Access Compliance Report

Public Rights-of-Way

(Curb Ramps)

Intersection ID: 30374	Main Street: EASTWAY_DR	Cross Street: EASTWAY_CROSSING_DR	Location: SW
ADA ID: 94E64FF5095C	Ramp Type: Directional1	Initial Pass/Fail: Pass	Overall Compliance: No
Severity Score: 5			
Codes/Mitigation Info/Possible Solution		Field Measurements/Component Compliance

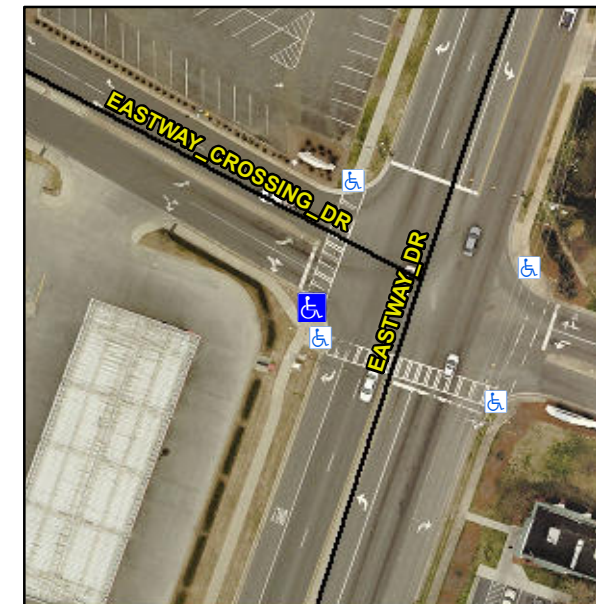
R304.5.3, R304.2.3

Compliance	Description	Data	Compliance	Description	Data
N/A	Ramp Length (in)	68.0	Yes	Grade Break?	Yes
Yes	Ramp Width (in)	72.0	Yes	Grade Break Slope (%)	3.7
Yes	Ramp Slope (%)	5.1	No	Grade Break XSlope (%)	3.2
Yes	Ramp XSlope (%)	1.1			
N/A	Flare Type LT	N/A	N/A	Flare Type RT	N/A
No	Flare Slope LT (%)	13.3	N/A	Flare Slope RT (%)	15.1
N/A	Flare Traversable LT?	Yes	N/A	Flare Traversable RT?	No
Yes	Landing Length (in)	60.0	Yes	DWS Provided?	Yes
Yes	Landing Width (in)	72.0	Yes	DWS Contrast?	Yes
Yes	Landing Slope (%)	1.0	Yes	DWS Length (in)	25.0
Yes	Landing X Slope (%)	0.0	Yes	DWS Full Width?	Yes
N/A	Landing Curb? (Y/N)	N/A	Yes	DWS Offset LT (in)	2.0
N/A	Shared Landing?	No	Yes	DWS Offset RT (in)	27.0
Yes	Gutter Ponding?	No	Yes	Gutter Slope (%)	1.0
Yes	Gutter Lip Ht (in)	0.0	Yes	Gutter X Slope (%)	0.9
N/A	Painted X Walk1?	Yes		Road Slope (%)	2.6
	X Walk 1 Direction	To N		Road X Slope (%)	1.3
	X Walk 1 Width (in)	111.0		Clear Space?	Yes

X Walk 1 Slope (%)	2.6	N/A	Clear Space to XWalk (in)	N/A
	X Walk 1 X Slope (%)	1.3	Yes	Storm Grate/Utility Hazard?	No
Yes	Ramp inside XWalk1?	Yes		Storm Grate/Utility Type	
Yes	Any Obstructions?	No			N/A
	Obstruction Type		Yes	Surface Condition? (G/P)	Good
			N/A	Curb Slope (%)	1.7

Possible Solutions:

Remove & Replace Entire Ramp.
